Detailed Site Plan
Departure from Parking and Loading Standards
Alternative Compliance
East Pines

DSP-19041
DPLS-488
AC-21001

SUBJECT: Detailed Site Plan DSP-19041
Departure from Parking and Loading Standards DPLS-488
Alternative Compliance AC-21001
East Pines

Figure 1: Site Development Plan

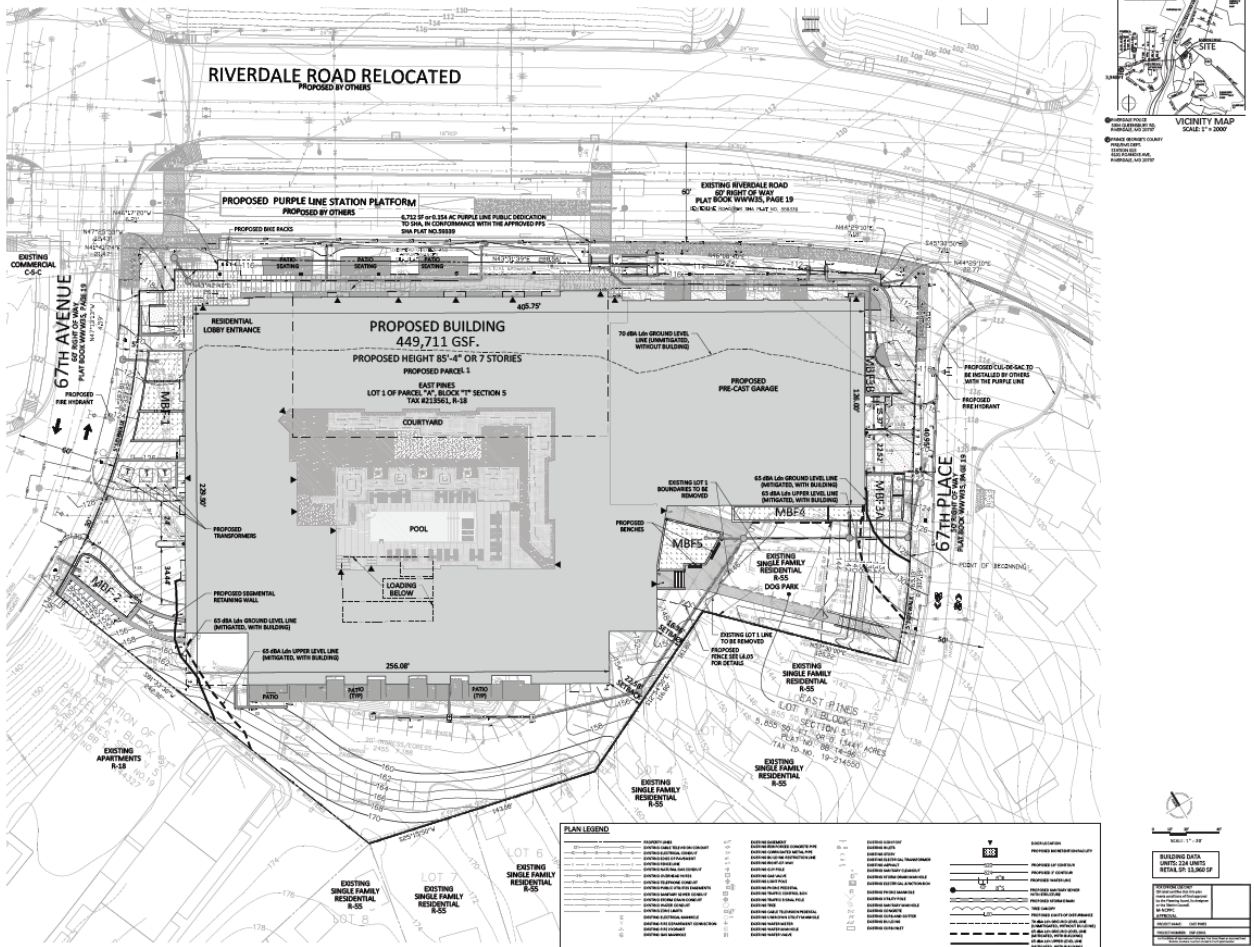
The parking structure at the northeast corner of the building includes spaces for 303 vehicles. As 553 parking spaces are required for the proposed development, a companion DPLS-488, is under concurrent review as discussed in Finding 7. Two internal loading spaces are shown, but a minimum of three are required to conform with Part 12 of the Prince George's County Zoning Ordinance. DPLS-488 did not request a reduction in the quantity of required loading spaces. Staff has recommended a condition for an additional loading space to be provided. An interior pick-up and drop-off area is provided, adjacent to the residential lobby of the building, for residents and ride share services.

However, staff is concerned regarding the width of the landscaped bufferyard between the proposed dog park and single-family dwelling identified as Lot 2, directly southwest. Given sufficient space is available, it is appropriate to provide the full 20-foot wide bufferyard in this location, with enhanced plantings to buffer the single-family dwelling.

- o. Revise the landscape plan and the associated Section 4.7 schedule for the portion of the property line where the dog park is located. The applicant shall revise the plan to provide the required full 20-foot-wide landscaped bufferyard to be planted with double row staggered planting of predominantly evergreen trees of a minimum two species.
